ROLSTON / FRAZER SUBDIVISION

Engineering Comments: FINAL PLAT COMMENTS (should be addressed prior to submitting the FINAL PLAT for review and/or signature by the City Engineer):

Revised for the March 17th meeting:

DETAIL SITE PLAN

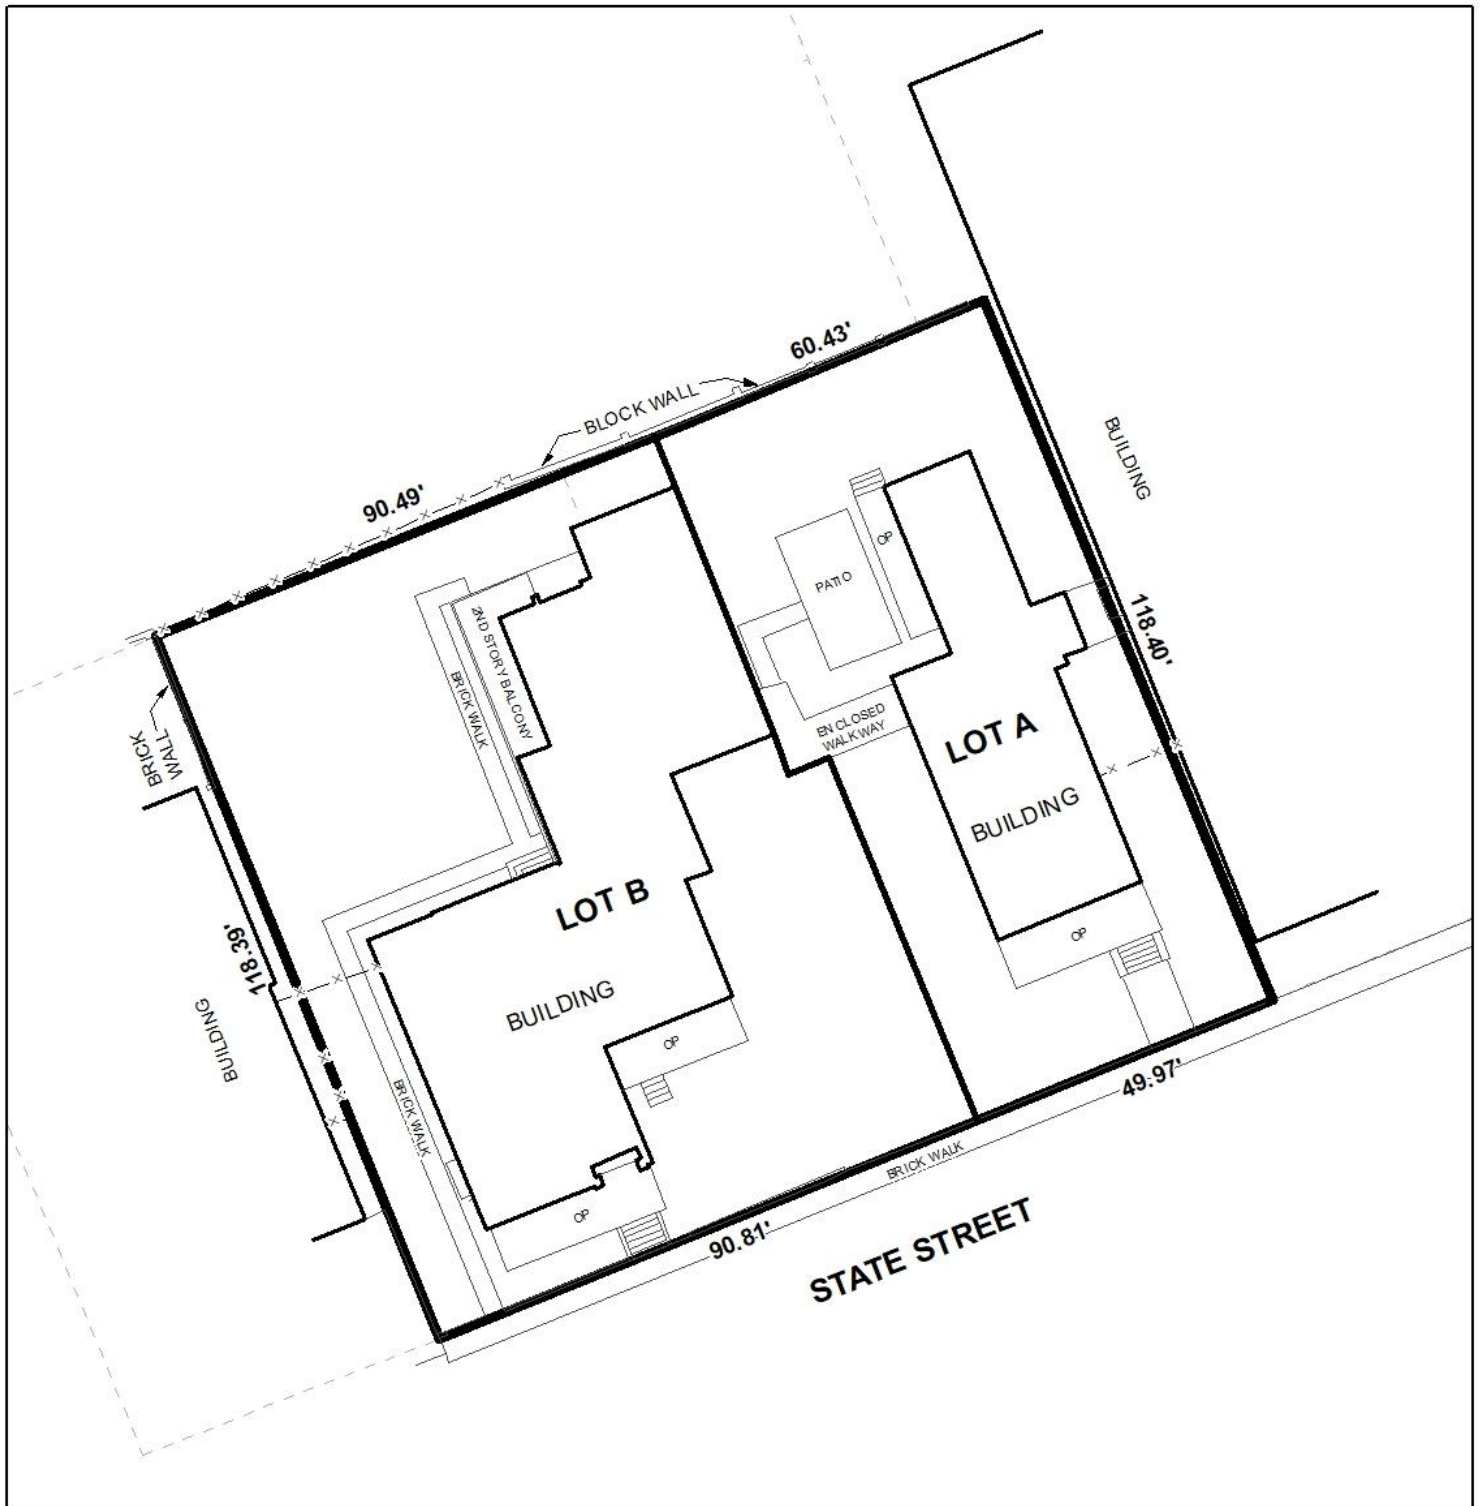
- B. Provide information on the handwritten "A" and "B" shown on the map.
- C. Add a graphic scale.
- D. Add a Vicinity Map with street names.
- E. Provide a Subdivision Name.

The proposed lots front State Street, which is a minor street with curb and gutter requiring a 50-foot right-of-way width. The right-of-way width of State Street is not indicated on the preliminary plat. Therefore, the plat should be revised to indicate the right-of-way width of State Street, if approved, and dedication should be required to provide 25 feet from the centerline of State Street, if currently less.

The preliminary plat does not provide the lot sizes. Therefore, the plat should be revised to label each lot with its size in square feet and acres, or a table should be furnished on the Final Plat providing the same information. As the proposed Parcel 1 is less than the 7,200 square feet required in Section V.D.2. of the Subdivision Regulations, a waiver will be required, if approved. The Zoning Ordinance allows up to 75% maximum site coverage within T4 Sub-districts, and a note should be required on the Final Plat stating such, if approved.

- 1) revision of the plat to indicate the right-of-way width of State Street on the Final Plat, and dedication to provide 25 feet from the centerline of State Street, if currently less;

- 2) placement of a note on the Final Plat stating that a twelve-foot (12') maximum building setback is required on the primary street frontage;
- 3) revision of the plat to label the lots with their sizes in both square feet and acres, or the furnishing of a table on the Final Plat providing the same information;
